Long Meadow Brook, LLC Development Naugatuck, Connecticut

King's Mark Environmental Review Team Report

Environmental Review Team Report

**Zoning Commission
Naugatuck, Connecticut**

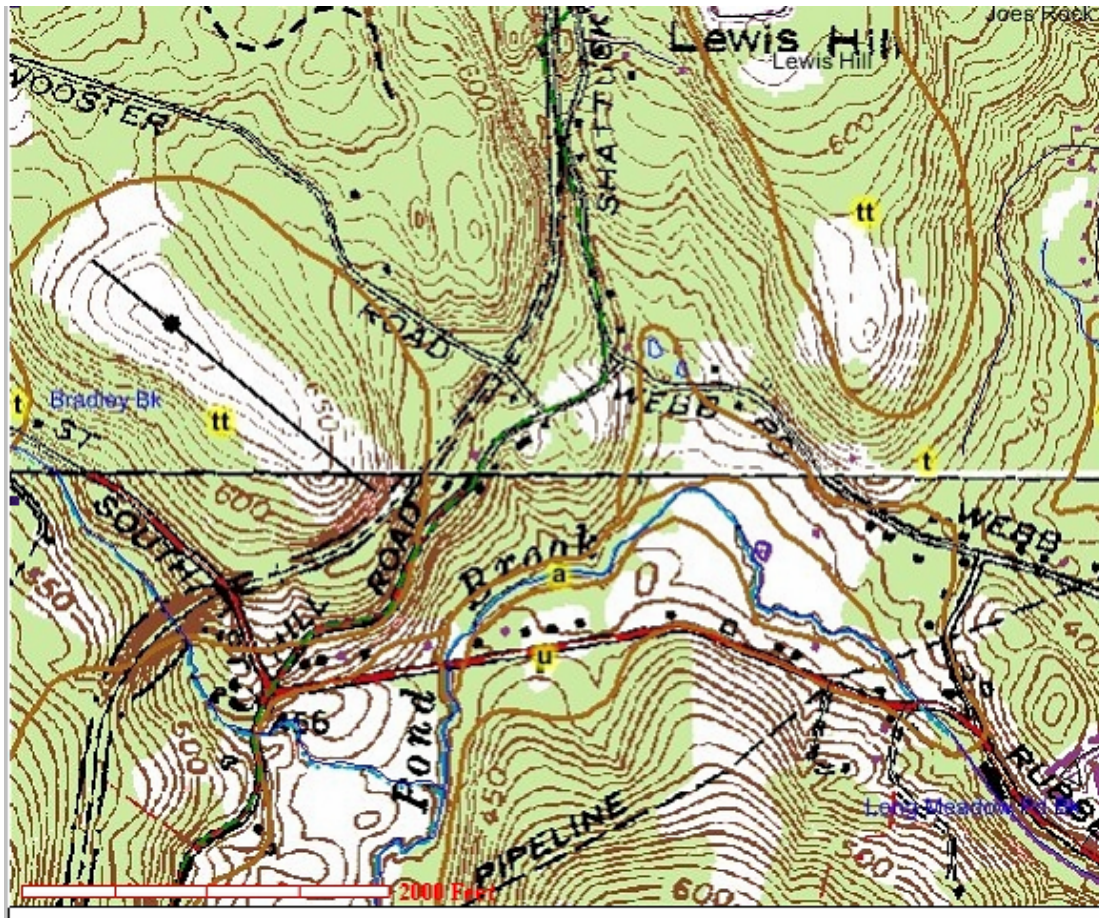
Long Meadow Brook occupies a valley in Naugatuck that has steep sides and is relatively narrow (see Figure 1). Drumlin shaped hills with elevations between 600->800 feet surround the valley. The proposed development is planned for a parcel located where the valley is anomalously wide, about 0.25 miles. Here the valley bottom is a relatively flat flood-plain and terrace.

The surficial geology (see Fig. 1) consists of deposits of glacial till on the uplands and melt-water stream deposits in the valley bottom (Flint, 1978). Modern river alluvium overlies some of the glacial stream deposits. The till on bordering hills is thicker than normal and in some locations shows evidence for two types of till (two different ages?). Till was observed in the field where it had been excavated (Fig 2, 3). There, the till was rocky and clayey. The clay content rendered the artificially steepened slopes subject to small amount of soil creep, evidenced by bent tree-trunks (fig. 2). This suggests that care should be taken not to create over-steepened slopes in areas where the till will be excavated to make level plots on which to build.

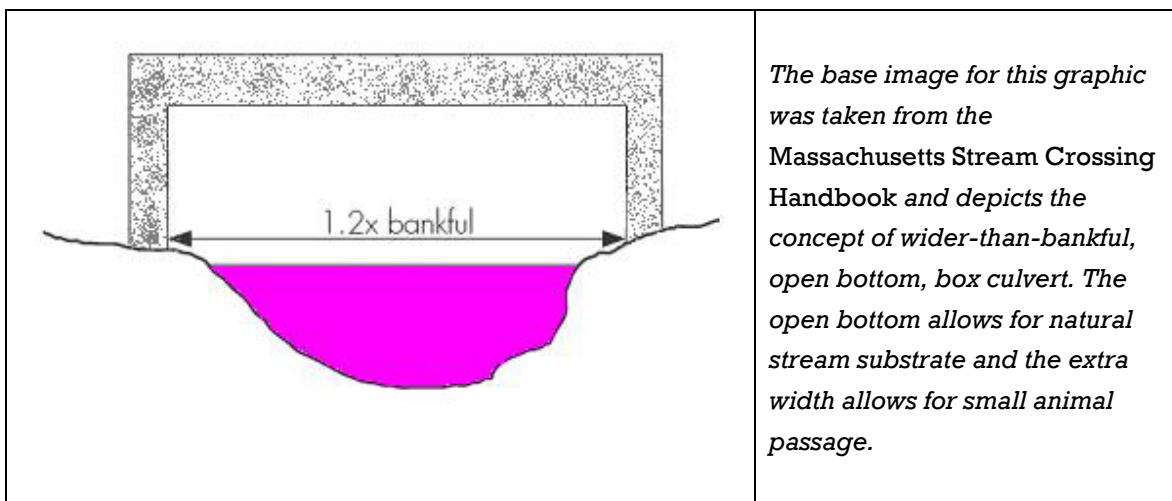
This view is along the proposed main road looking east at the first crossing. It was frozen at the time of the visit but day/night freeze/thaw action allowed for the melting and freezing which caused this ice over. A 12 inch reinforced concrete pipe is proposed.

The second stream (westernmost) is proposed to be culverted in a 15 inch reinforced concrete pipe under the proposed road. This unnamed stream has a 95 acre± natural drainage area, with slopes frequently in the 11 to 19 per cent range. This stream passes under Webb Road in a 48 inch pipe. This reviewer concurs with Mr. Shepard's suggestion of using a larger passage at road station 16+90. This would be more in keeping with the current best management practices of crossings. For this type of crossing the Army Corps of Engineers General Permit specifies:

The open bottom culvert using a minimum 1.2 times bankful width is the current convention. This width allows for small wildlife passage along the stream bank during periods of normal flow. It is depicted in the *Massachusetts Stream Crossing Handbook* which is available at:
